BUCKINGHAM TOWN COUNCIL

**BUCKINGHAM TOWN COUNCIL
INTERIM COUNCIL
MONDAY 15TH APRIL 2019**

19/00902/ADP Land adj. 73 Moreton Road

19/00924/APP Land off Market Hill/West Street MK18 1HL

Southern end of site and Brae Lodge

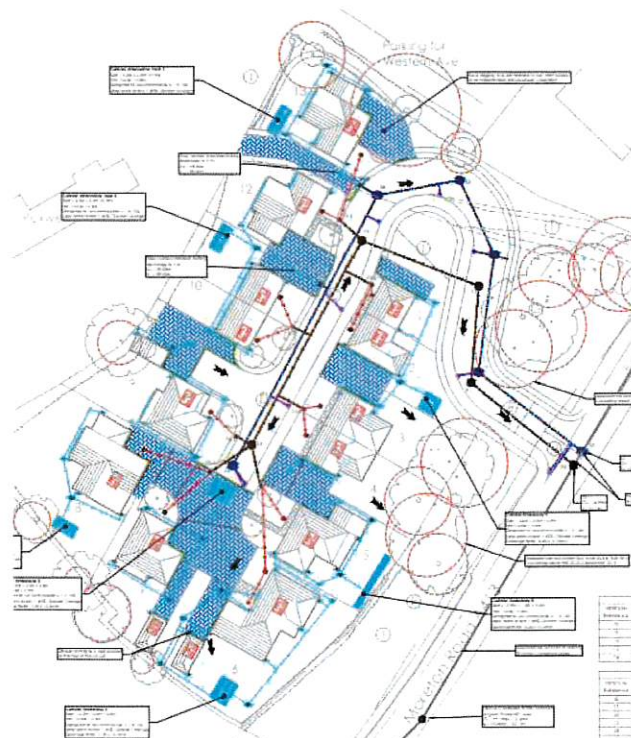
A short piece of footpath with dropped kerb and tactile paving is shown to the north and south of the Moreton Road access, and along the south and east side of the estate road and across the end, but not back along the other side. A s278 Highway Works agreement is yet to be signed. At present it looks as if this means walking in the unsurfaced Moreton Road verge to get to the nearest bus stops (Western Avenue) or to a safe place to cross (above Addington Road the Moreton Road levels out to give good visibility both ways). Any footpath south will encourage its use and as it ends at the wall of Brae Lodge this is emphatically not safe, whether users cross

the road at this point or continue on down the hill in the carriageway until there is a footpath again (about 50m, all exactly opposite the permitted kerbside parking; see map on p.1).

Section of landscaping drawing; red circles are Root Protection Areas, small triangles are bat & bird boxes

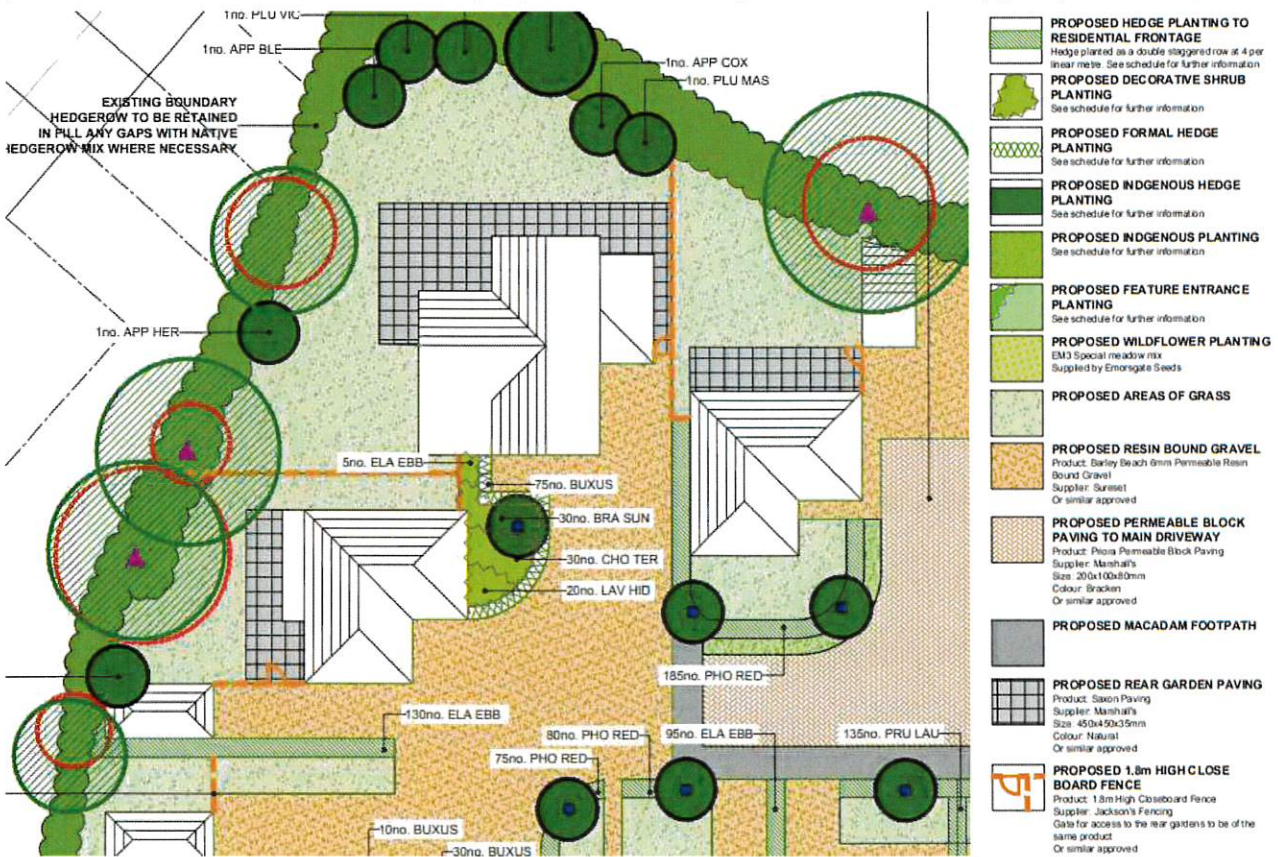
The landscaping as proposed will alleviate the bareness of the paving and small lawns by having shrubs forming a hedge along the frontage (photinia, Portuguese laurel) with small ornamental pear trees at intervals. The trees proposed for back gardens include apple, pear and plum.

2. Design
a) Block 1

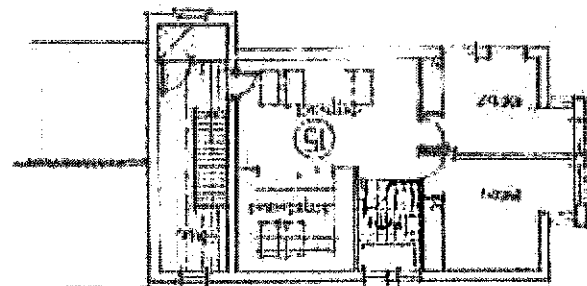
The people who live in Flat 8 (top floor, left hand end) have a double garage also at the left hand end of the block, meaning they have to walk their shopping etc. downhill to the gate at the right hand end of the block and all the way back up hill to the hallway at their end of the building. A remodelling of the store room at the left hand end could allow a through passage to make a shorter access – making a hallway access at this end of the building would involve the loss of a garage the stairwells are where the small single windows are). The right hand hallway which already is the full depth of the building at ground level could have a door in this wall as well for the convenience of residents of the central flats. The public area between the block and the boundary is very narrow and public access from the well-used and well-surveyed west side would be both more useful (for residents and postmen) and safer. The proposed doors on the east side of the stairwells could be retained but kept locked.

Access to the flats is proposed via a gate and described as 'secure' so presumably depends on the gate being self-closing and lockable. A locked gate prevents deliveries to the door, and both lock and self-closer may be awkward for residents with disabilities.

The cycle racks are presumably standard Sheffield hoops to which the cycle can be padlocked, and for this block are at the furthest accessible point, by the storerooms top left. It might be preferable to have undercover cycle parking in some of the store space (which could have access from the new cross corridor proposed above). Otherwise residents might prefer to take their machines into the hallways for safety, which clutters up the hallway and could be a hindrance to escape in an emergency situation.
